LETTER OF OBJECTION to Listed Building Consent 2024/0286/L and Planning Application 2023/5339/P submitted 22 Feb 2024.	
Site Address: Alexandra Road, Rowley Way, London NW8 0SN	
'External and internal works including replacement of existing single glazing with double glazing ¹ , removal of domestic hot water cylinders and installation of new heating interface unit, emitters and associated pipework.'	
Development Type: 'Listed Building Consent' and 'Residential Minor Alterations'.	
We wish to lodge objections to the application on the following grounds:	
1	GLAZING - This is not double glazing as conventionally understood! It is a very expensive novel form of vacuum glass individually fitted into 40 year plus old timber windows many in dubious condition. It is not a practical or sustainable solution.
2	HEALTH & HERITAGE - No consideration has been given in the proposal to avoid creating condensation, damp and mould by the change from a warm structure to intermittent heating. No adjustments to improve the ventilation to the flats are not proposed.

Objection to Planning Application Listed Building Consent 2024/0286/L and Planning Application 2023/5339/P.

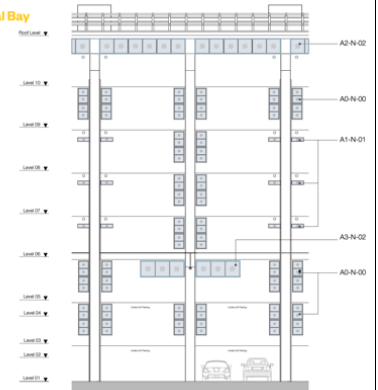
The earlier applications, for new distribution pipework propose that **three** pipes travel up every alternate fin.

The **three pipes** are shown on the technical drawings, but the only close-up 3D visualisation shows an instance where **only one** pipe runs up.

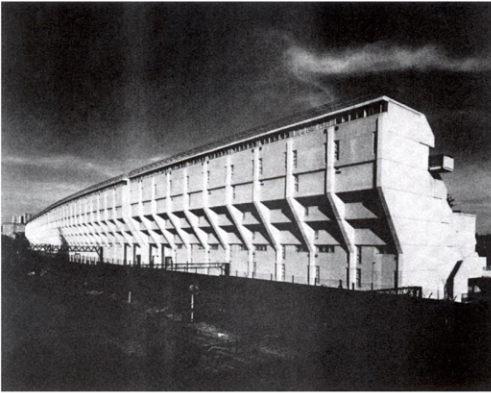
In the section '**Listed Building**' in answer to the question

*'Do the proposed works include.....
c) works to any structure or object fixed to a property (or buildings within its curtilage) internally or externally?'*

The applicant has ticked the **No** box. This is incorrect.

- the original cupboards are being replaced in many locations, as we saw in the pilot flat.
- the original recessed skirting and shadow gap detail is being replaced with trunking
- the cylinders are being removed.
